**Notice to all Bidders.****TENDER ADDENDUM AND CLARIFICATION No. 07 (TAC 07)****RE: EPC Tender for 220/132kV New Kilifi & Extension of Existing 220/33kV Malindi Substations****IFB OCBI No: KETRACO/PT/029/2025-Lot 4**

The following amendments are made to the specified provisions for the bidding documents for EPC Construction for the Design, Supply, and Installation Services for 220/132 kV New Kilifi substation & Extension of Existing 220/33 kV Malindi substation (IFB OCBI No: KETRACO/PT/029/2025-Lot 4).

**2. Auxiliary Transformers TDS**

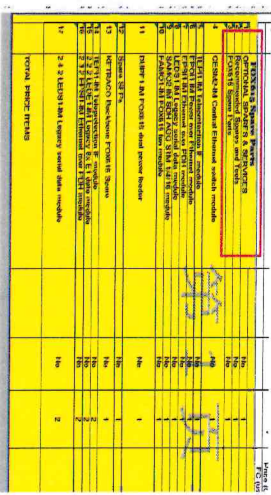
The Technical Datasheet of 33/0.415kV and 11/0.415kV Auxiliary Transformers has been revised and enclosed with TAC 7
